**TYPE III – MODIFICATION
STAFF REPORT AND RECOMMENDATION**

Revised August 15, 2017

FILE NO.: MD 17-01, MD 17-02, MD 17-03, MD 17-04, MD 17-05, and MD 17-06:
Historic Review for the designs of six (6) cottage style homes in the Canemah
Historic District.

REQUEST: The applicant is requesting design approval for the construction of six (6) new
construction cottage style dwelling units, with preservation incentives to
adjustment the front, side, and rear setbacks, in the Canemah Historic
District.

Proposed House 1:

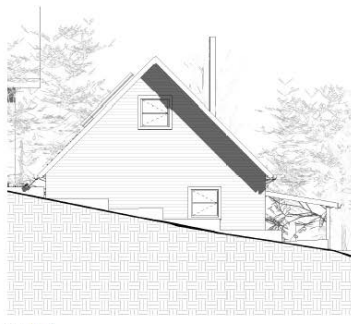
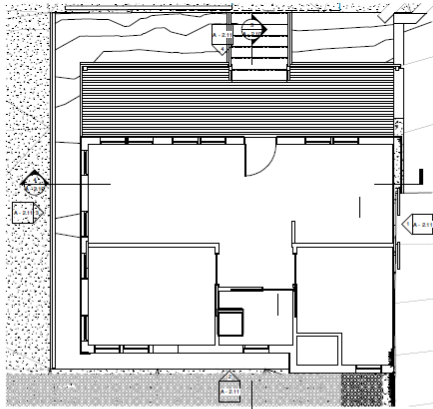
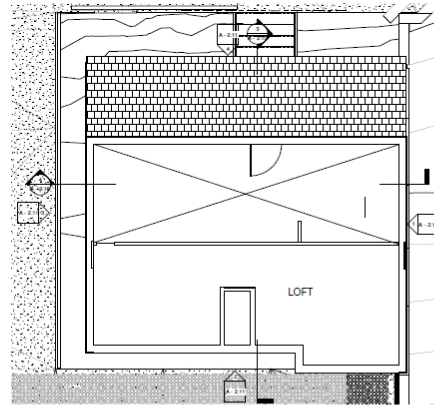
In the design of home number one, the applicant has indicated that they are planning to remove a significant portion of the abutting topography, creating a cutout for the home and a twelve (12) foot wide driveway on the existing lot. This home will also be located directly upon the east property line.

The proposed landscaping in front of the front of the home is unclear. The applicant will need to go through Geotechnical Review along with Site Plan and Design Review.

- a. Retaining and structural walls shall be minimized; to be faced or finished in stone, mortared basalt, or concrete, and not exceed 3 ½ feet, to complement the Canemah Neighborhood.
- b. Concrete foundations shall have a natural, parged or painted finish.
- c. Exposed foundations shall be site screened with vegetation if concrete or masonry exceeds 3½ feet, or if pilings or posts are 1½ feet above grade.
- d. A minimum of 5 shrubs and groundcover shall be installed along the façade of the front porch.
- e. Roofing shall use traditional materials such as wood shingles, composition, and metal shingles.
- f. Skylights shall be installed in inconspicuous roof slopes and skylights shall be mounted close to the roof plane, and not visible from the right-of-way.

Proposed House 2:

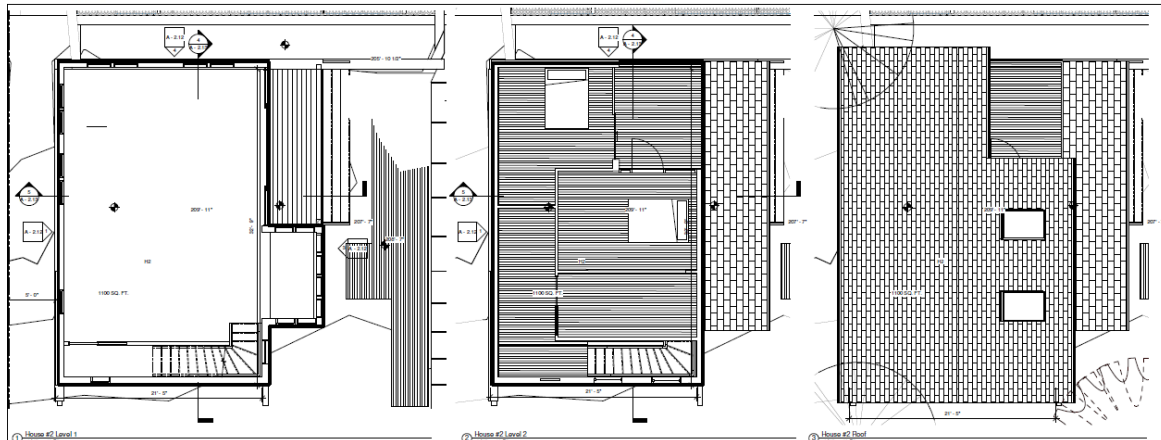
Finding: Complies with Condition. House two (2) is located approximately 40 feet south of house one (1) on the site plan, and appears to be designed as an 1100 square foot 1 ½ story modern Vernacular home completely sided in horizontal shiplap. The deck on east side of the house is with a flat, slightly elevated, with no front railing. The east side of the first story is has four large full light windows, creating a French door like entrance. To the south of the main entrance is a small bump out from the main building on which there are four small square double hung windows. To the south of the bump out is one large rectangular double hung window. The east facing deck is also covered by overhanging eave. On the second story of the east side there is a portion of the roof that has been removed to make space for a second story outdoor seating area. The entrance leading to this outdoor seating area is composed of two full light glass doors with two large square windows above the glass doors on the east side of the cutout and one full light glass door surrounded by window on south side of the cutout. The outdoor seating area is bordered on the east and west sides by a railing with thin spindles and a top rail. On north side of the first story there are four large rectangular double hung windows and one large rectangular double hung window on the second story.

The first story on the south side of the house contains one small square double hung window with a concrete planter box along the foundation of the building. The side of the east-facing bump out is visible on the south side of the house; there are two small square double hung windows visible on the side of said bump out. On the second story of the south side of the home, a series of stepped windows are used. A large double hung rectangular window is illustrated to be near the top of the structure, stepping down to two small double hung square windows.

- a. Residential doors shall complement the design and detailing of the historic style with similar appearance to wood. Doors shall be designed in a stile and rail type; panel design; with upper portion glass. The primary door may be a solid panel door.
- b. Gable roof slopes shall have equal pitch. Gable primary roofs shall have a pitch of 8:12 or greater (6:12 for Bungalow). Porch or bay roofs may have lower slope, may have hip if style allows. Roofs shall have a minimum 1 foot overhang with a maximum of 3 feet.
- c. Windows shall match the member sizing, thickness and shadowline of painted wood windows. Windows shall also consist of the following designs: double, single hung, or casement. Wood clad shall be matching in color and finish. Non-wood fiberglass and aluminum windows are acceptable if in appropriate style, and matching wood in profile, shadowline, and if similar in

- d. Concrete foundations shall have a natural, parged or painted finish.
- e. Exposed foundations shall be site screened with vegetation if concrete or masonry exceeds 3½ feet, or if pilings or posts are 1½ feet above grade.
- f. Roofing shall use traditional materials such as wood shingles, composition, and metal shingles.
- g. Skylights shall be installed in inconspicuous roof slopes and skylights shall be mounted close to the roof plane, and not visible from the right-of-way.

Proposed House 3:

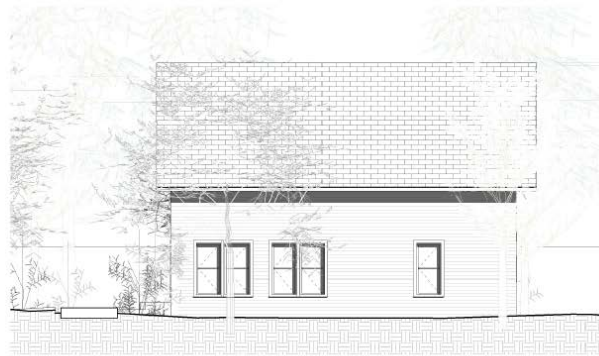
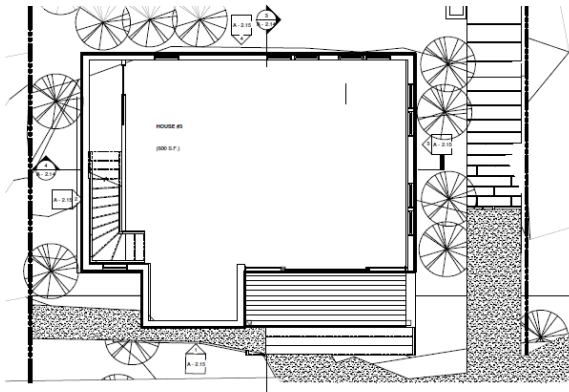
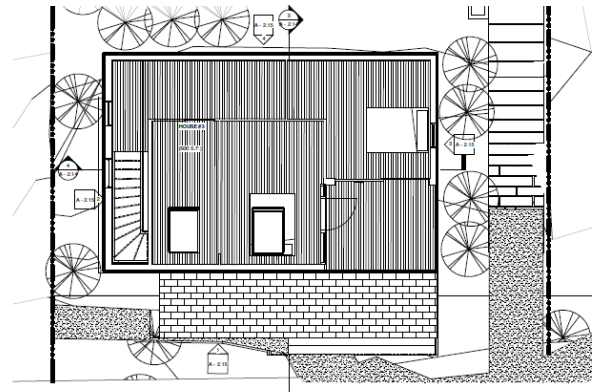
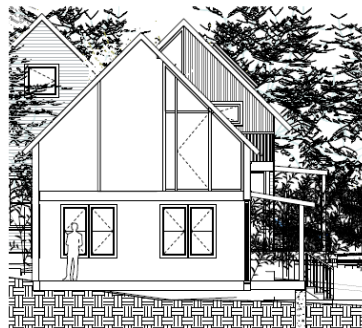
- Roofing shall use traditional materials such as wood shingles, composition, and metal shingles.
- Skylights shall be installed in inconspicuous roof slopes and skylights shall be mounted close to the roof plane, and not visible from the right-of-way.

- a. Primary residential doors shall complement the design and detailing of the historic style with similar appearance to wood. Doors shall be designed in a stile and rail type; panel design; with upper portion glass. The primary door may be a solid panel door. Sliding doors are not permitted.

- b. Gable roof slopes shall have equal pitch. Gable primary roofs shall have a pitch of 8:12 or greater (6:12 for Bungalow). Porch or bay roofs may have lower slope, may have hip if style allows. Roofs shall have a minimum 1 foot overhang with a maximum of 3 feet.

- c. Windows shall match the member sizing, thickness and shadowline of painted wood windows. Windows shall also consist of the following designs: double, single hung, or casement. Wood clad shall be matching in color and finish. Non-wood fiberglass and aluminum windows are acceptable if in appropriate style, and matching wood in profile, shadowline, and if similar in color and finish. If a non-wood style is proposed, a sample is required to be approved by the Historic Review Board.

- d. Concrete foundations shall have a natural, parged or painted finish.
- e. Exposed foundations shall be site screened with vegetation if concrete or masonry exceeds 3½ feet, or if pilings or posts are 1½ feet above grade.

- f. Roofing shall use traditional materials such as wood shingles, composition, and metal shingles.
- g. Skylights shall be installed in inconspicuous roof slopes and skylights shall be mounted close to the roof plane, and not visible from the right-of-way.

Proposed House 4:

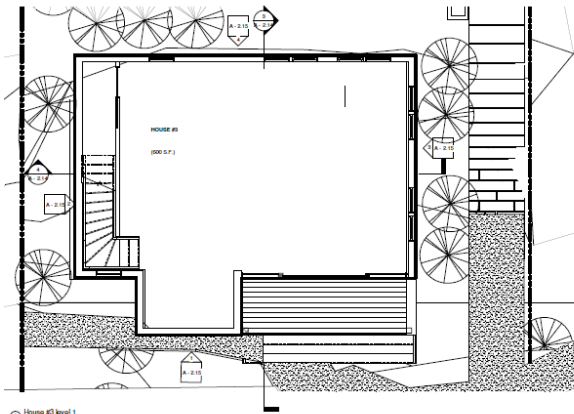
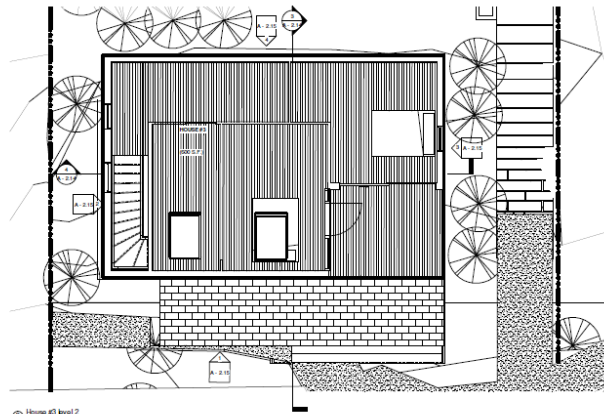
- Roofing shall use traditional materials such as wood shingles, composition, and metal shingles.
- Skylights shall be installed in inconspicuous roof slopes and skylights shall be mounted close to the roof plane, and not visible from the right-of-way.

- a. The main entrance of the house shall not be oriented towards the adjacent parking lot.
- b. Windows shall match the member sizing, thickness and shadowline of painted wood windows. Windows shall also consist of the following designs: double, single hung, or casement. Wood clad shall be matching in color and finish. Non-wood fiberglass and aluminum windows are acceptable if in appropriate style, and matching wood in profile, shadowline, and if similar in color and finish. If a non-wood style is proposed, a sample is required to be approved by the Historic Review Board.

- c. Residential doors shall complement the design and detailing of the historic style with similar appearance to wood. Doors shall be designed in a stile and rail type; panel design; with upper portion glass. The primary door may be a solid panel door. Sliding doors are not permitted on any portion of the house.

- d. Concrete foundations shall have a natural, parged or painted finish.
- e. Exposed foundations shall be site screened with vegetation if concrete or masonry exceeds 3½ feet, or if pilings or posts are 1½ feet above grade.

- f. Roofing shall use traditional materials such as wood shingles, composition, and metal shingles.
- g. Skylights shall be installed in inconspicuous roof slopes and skylights shall be mounted close to the roof plane, and not visible from the right-of-way.

House 6:

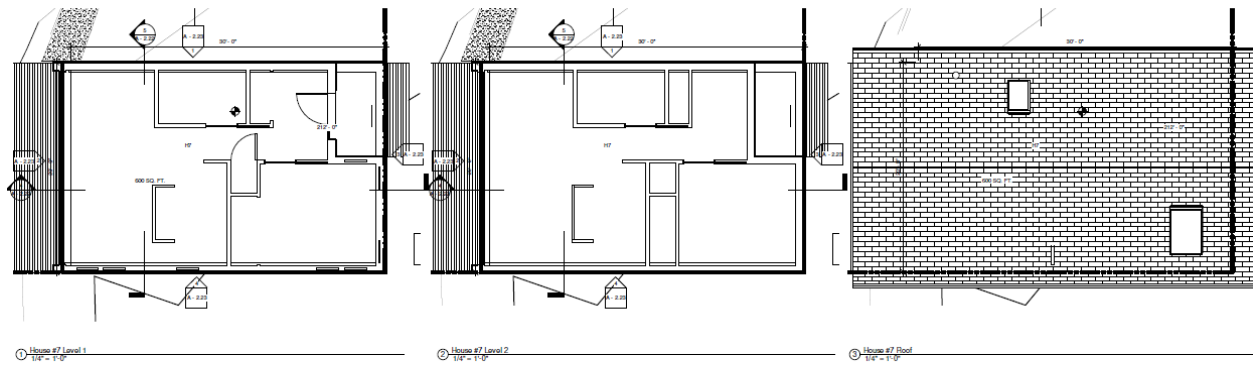
- Roofing shall use traditional materials such as wood shingles, composition, and metal shingles.
- Skylights shall be installed in inconspicuous roof slopes and skylights shall be mounted close to the roof plane, and not visible from the right-of-way.

- a. Residential doors shall complement the design and detailing of the historic style with similar appearance to wood. Doors shall be designed in a stile and rail type; panel design; with upper portion glass. The primary door may be a solid panel door. Sliding doors are not permitted on any portion of the house.

- b. Windows shall match the member sizing, thickness and shadowline of painted wood windows. Windows shall also consist of the following designs: double, single hung, or casement. Wood clad shall be matching in color and finish. Non-wood fiberglass and aluminum windows are acceptable if in appropriate style, and matching wood in profile, shadowline, and if similar in color and finish. If a non-wood style is proposed, a sample is required to be approved by the Historic Review Board.

- c. Gable roof slopes shall have equal pitch. Gable primary roofs shall have a pitch of 8:12 or greater (6:12 for Bungalow). Porch or bay roofs may have lower slope, may have hip if style allows. Roofs shall have a minimum 1 foot overhang with a maximum of 3 feet.

- d. Concrete foundations shall have a natural, parged or painted finish.
- e. Exposed foundations shall be site screened with vegetation if concrete or masonry exceeds 3½ feet, or if pilings or posts are 1½ feet above grade.

- f. Roofing shall use traditional materials such as wood shingles, composition, and metal shingles.
- a. Skylights shall be installed in inconspicuous roof slopes and skylights shall be mounted close to the roof plane, and not visible from the right-of-way.
